Illinois Tollway Base Sheet Revisions

Section M		Base Sheet Drawings	
Drawing	Modification Summary	Effective: 2020-03-01	
Pole Assembly (ITS)-Series 1000			
M-ITS-1000	Elevation Views Pole Mounted ITS Element Assembly		
	Use 1 1/2" stainless conduits for power and fiber to ITS Enclosure instead of 2". Corrected the MVDS mounting height on elevation details Use 1 1/2" stainless conduit for ITS Disconnect switch		
M-ITS-1001	General Notes Pole Mounted ITS Assembly		
	Note added on placement of battery enclosure		
M-ITS-1002	ITS Standard Foundation		
	Note added to use 12 ft helix foundation for slopes over 1:6		
M-ITS-1003	ITS Concrete Service Pad		
	Shows option for back-to-back mounted ITS enclosures.		
M-ITS-1004	Cabinet Wiring Diagram - ITS Pole Mounted Enclosure (Solar Powered MVDS) (2 sheets)

M-ITS-1600

WEIGH-IN-MOTION CABINET AND FOUNDATION DETAILS

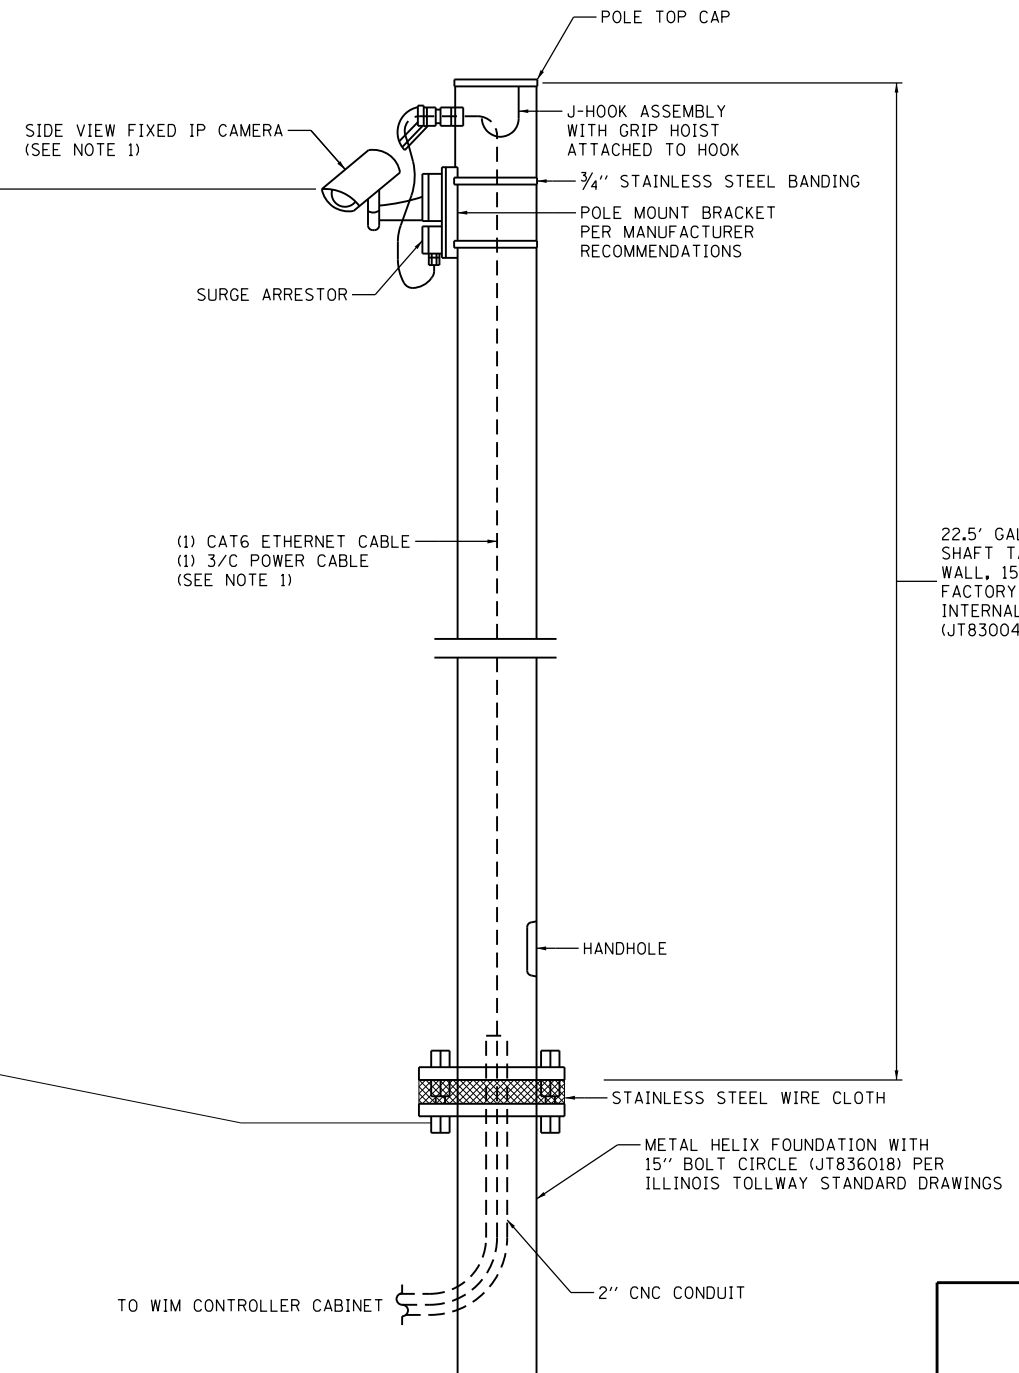
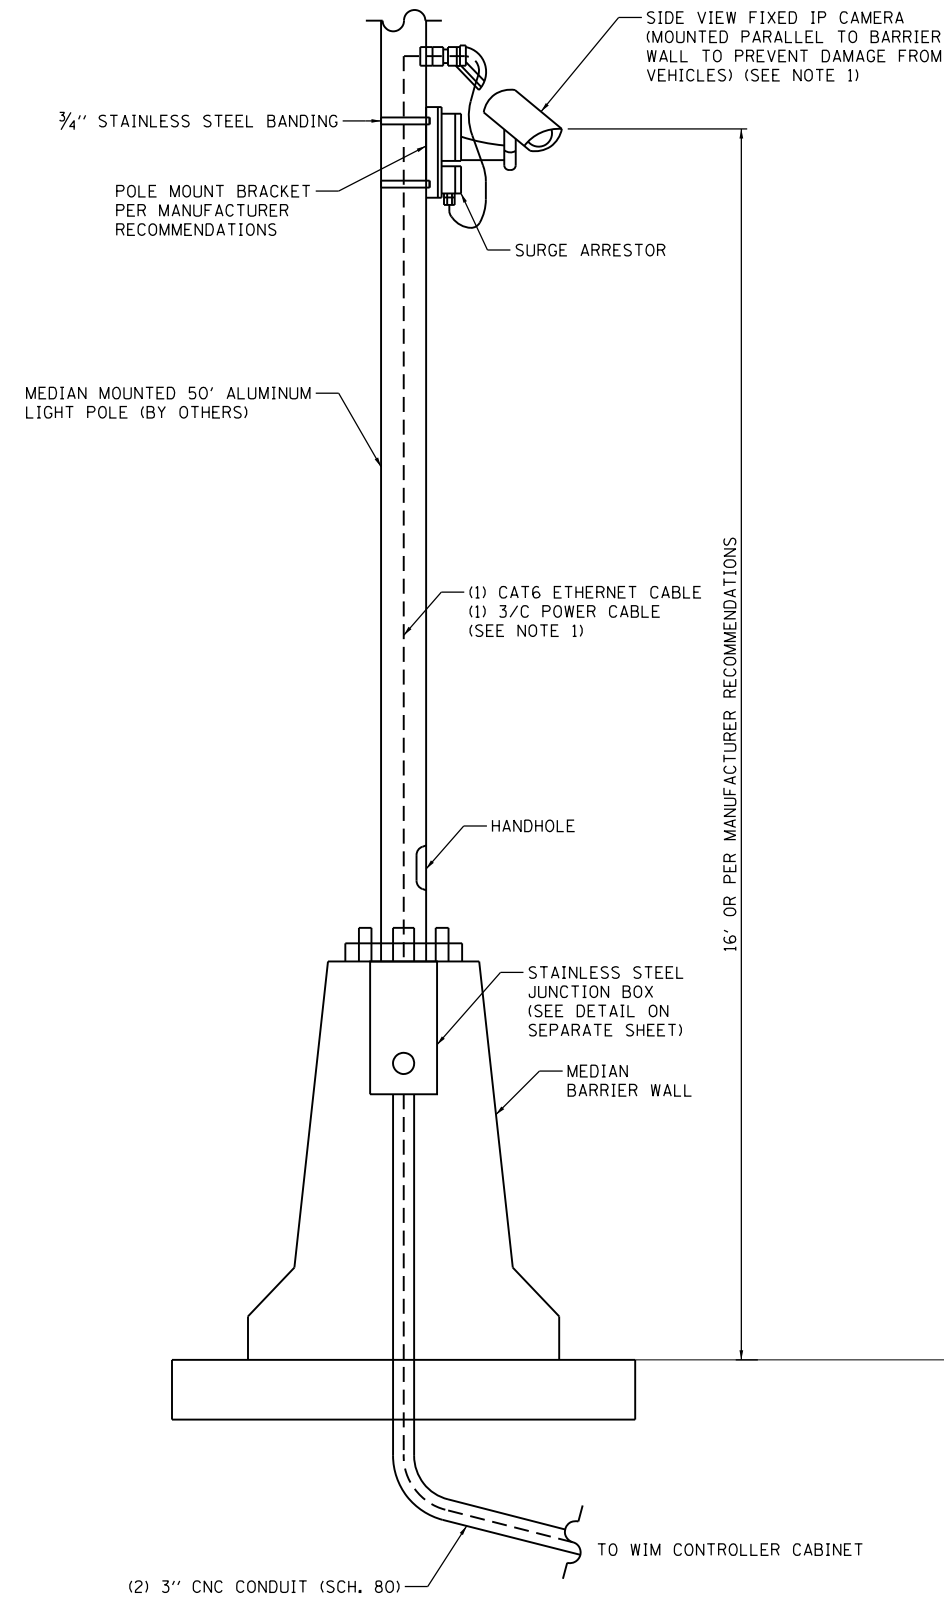
Show two permanent antennas installed on top of WIM cabinet		
M-ITS-1603	Weigh-In-Motion Detector Loop and Quartz Sensor Detail		
	Show parking area for one vehicle for annual calibration		
M-ITS-1607	Weigh-In-Motion Height Detector		
	Added detail for overheight detector		
Flashing Sign Beacon (ITS)-Series 1700			
M-ITS-1701	Cabinet Layout and Wiring ITS Pole Mounted Enclosure (1-CCTV and Flashing Sign Beacon)		
	Update enclosure layout		
IPDC Facility (ITS)-Series 1800			
M-ITS-1800	IPDC Facility		
	No change		
Conduit Details at Integral Abutment Bridge (ITS)-Series 1900			
M-ITS-1900	Conduit Details at Integral Abutment Bridge with MSE Wall (Sheet 3)		
	No change		
100 FT. Monopole (ITS)-Series 2000			
M-ITS-2000	100 FT. Monopole Closed Circuit Television (CCTV) Camera Tower		
	Pole cap to use hex head screws		
	Show revised grounding around service pad
